Planning Application No 18/02753/OUT

Buckden Parish Council submission to DMC

7.35. Satisfactory Resolution of Additional Traffic Impacts on Local Roads

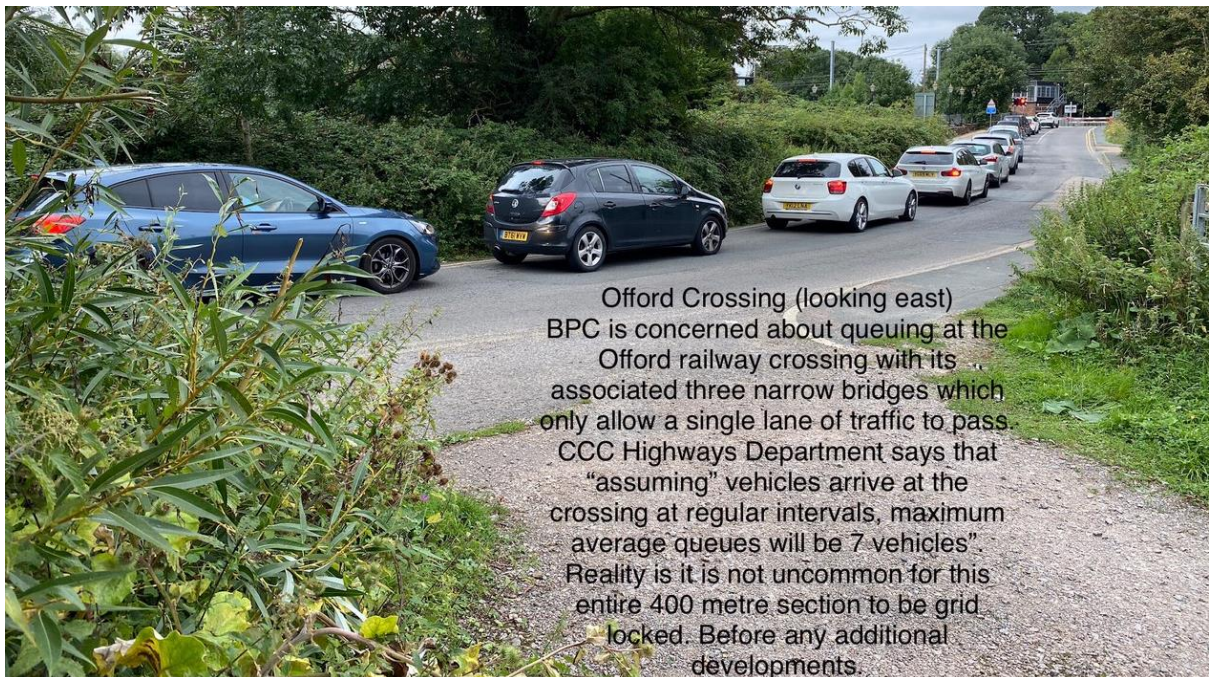
*"Successful development of the site will require: [among other things] a. provision of suitable access and **satisfactory resolution of additional traffic impacts on local roads and the A1.**"*

There will be undoubtedly be additional impacts on local roads. Both the applicant's traffic experts, Pell Frischmann, and the County Council Highways Department state as much in specific terms. Extrapolating from the vehicle movements numbers Pell Frischmann have stated it must be expected that there will be between 250 and 260 additional vehicle

movements in the village in the peak a.m. hour. It is self-evident that such an increase will have additional traffic impacts. Neither in their 2018 report, nor subsequently, have Pell Frischmann made any proposals as to how to resolve them. They simply assume that the village must absorb those impacts, detrimental though they are.

Traffic from the development within the built area of the village travelling to access the A1

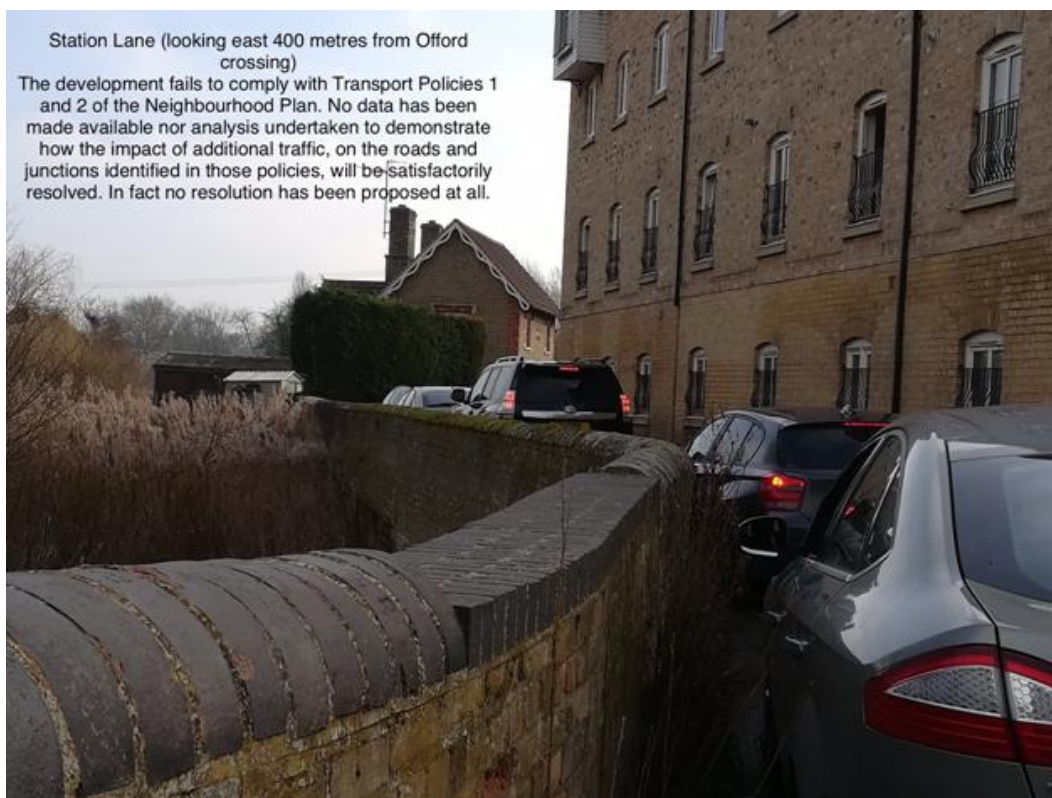
The Pell Frischmann report describes the percentage of vehicular traffic that will use St Hugh's Road, Silver Street, Church Street and High Street. They claim the majority will use Silver Street and Church Street to access High Street and the A1 at the roundabout. A minority will use St Hugh's Road and High Street to access the A1 at the north end of High Street.

This ignores the fact that Silver Street is narrow, with cars parked on it all day, this route entails a difficult right turn onto Church Street and then a difficult and narrow left turn onto High Street. By contrast St Hugh's Road is easy to turn right into, and it has a much easier turn onto High Street, either left or right. Drivers will always take the path of least resistance, which is St Hugh's Road. The Parish Council has raised this with the Highways Department who have not offered any rationale as to why the Pell Frischmann data is right.
